PE12-019

APPENDIX 17

July 6, 2012 - Internal Mazda
communication regarding
NHTSA question of Mazda
update.

SUBJECT: Safety Recall 04S25: *Update*
All 2002 through 2004 Model Year Left Hand Drive (LHD) Escape Vehicles Equipped
with 3.0L Engines
Accelerator Cable Replacement

FIGURE 1

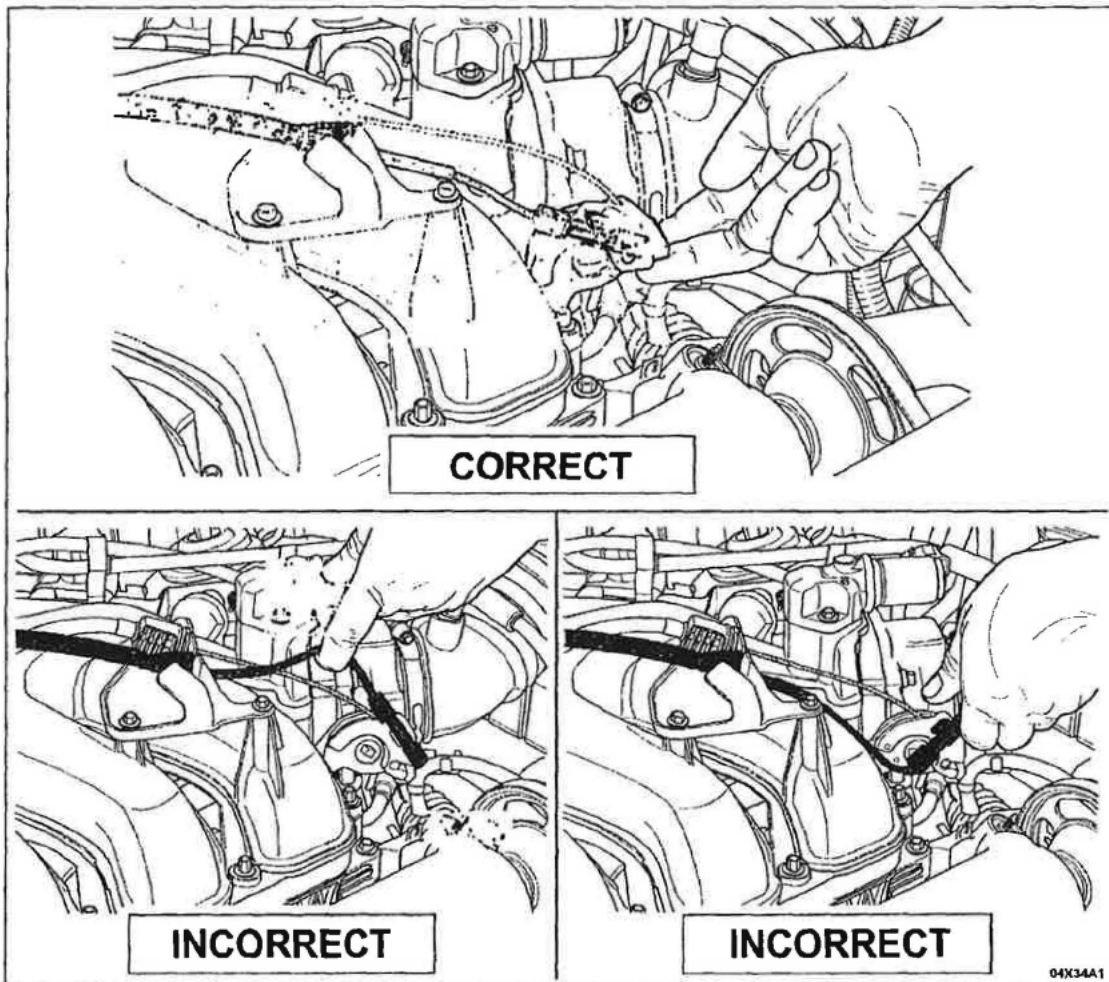
NEW

CAUTION: Damage to the speed control cable may result if the throttle body cam is rotated by lifting up on the speed control cable or the speed control cable connector end. When disconnecting the accelerator cable from the throttle body, rotate the throttle body cam only by lifting up on the cam itself. See Figure 1.

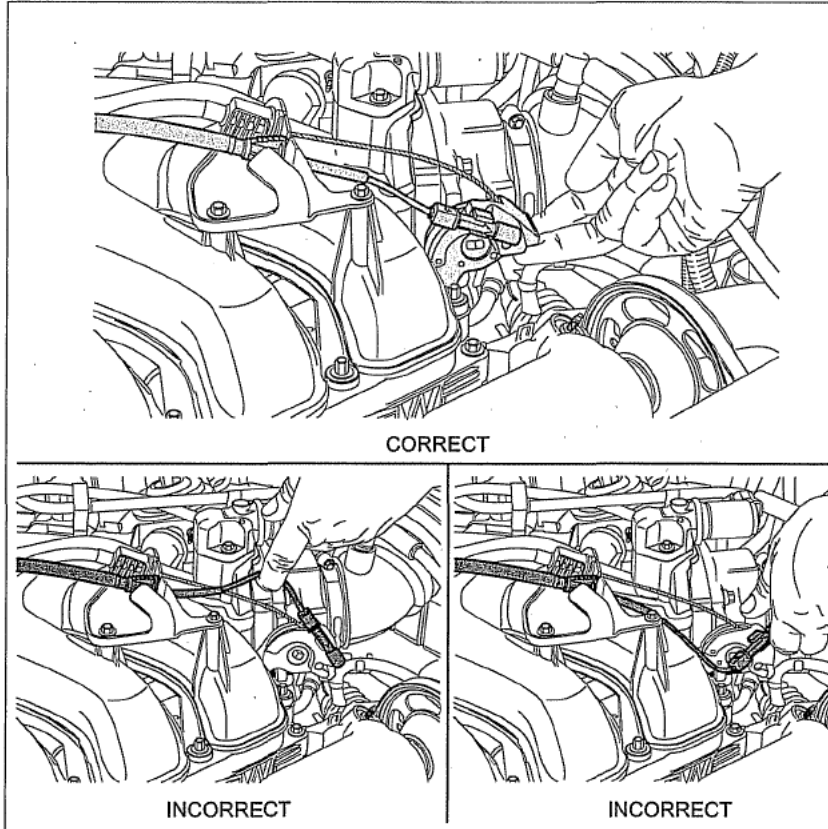
CAUTION: Damage to the speed control cable may result if the throttle body cam is rotated by lifting up on the speed control cable or the speed control cable connector end. When disconnecting the accelerator cable from the throttle body, rotate the throttle body cam only by lifting up on the cam itself. See Figure below.

FIGURE 1

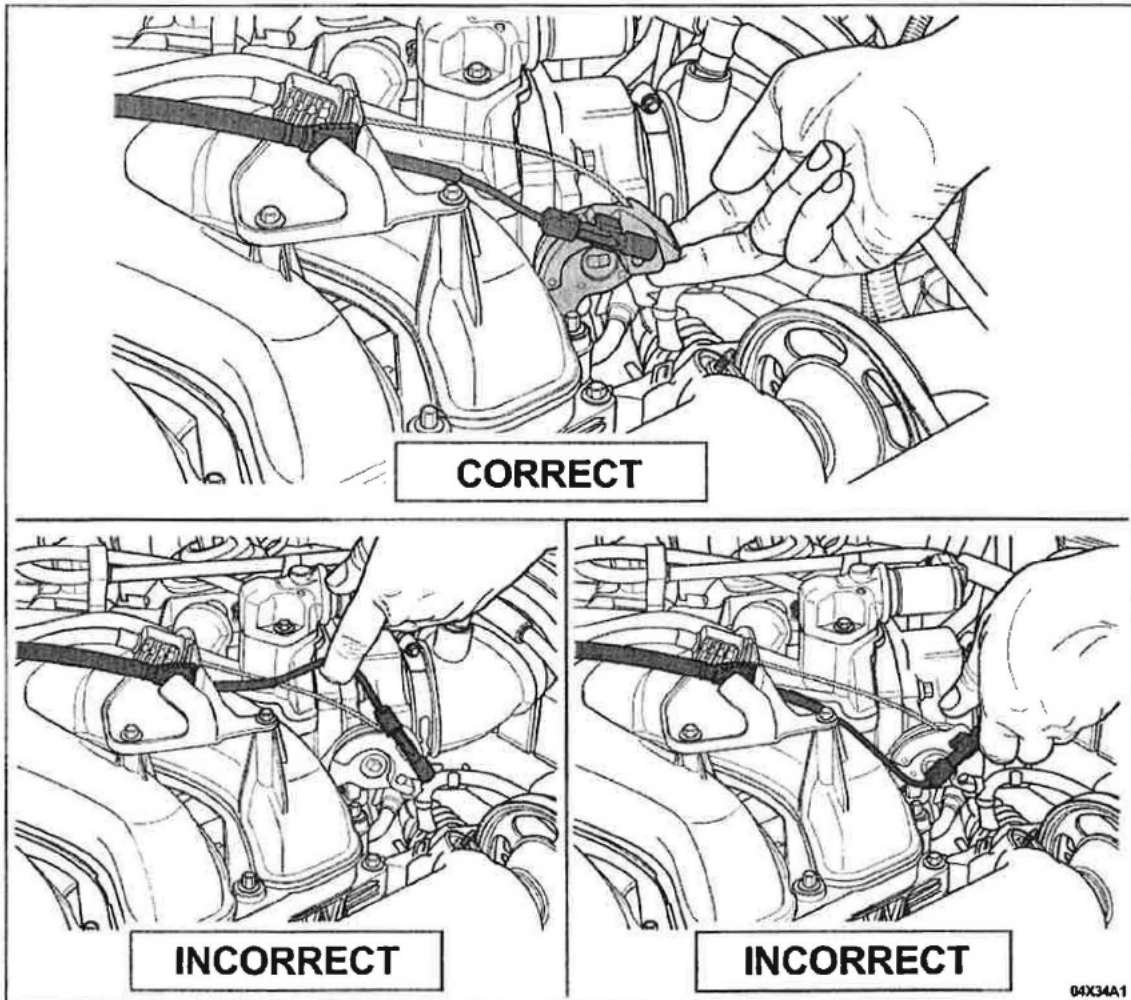
NEW

CAUTION: Damage to the speed control cable may result if the throttle body cam is rotated by lifting up on the speed control cable or the speed control cable connector end. When disconnecting the accelerator cable from the throttle body, rotate the throttle body cam only by lifting up on the cam itself. See Figure 1.
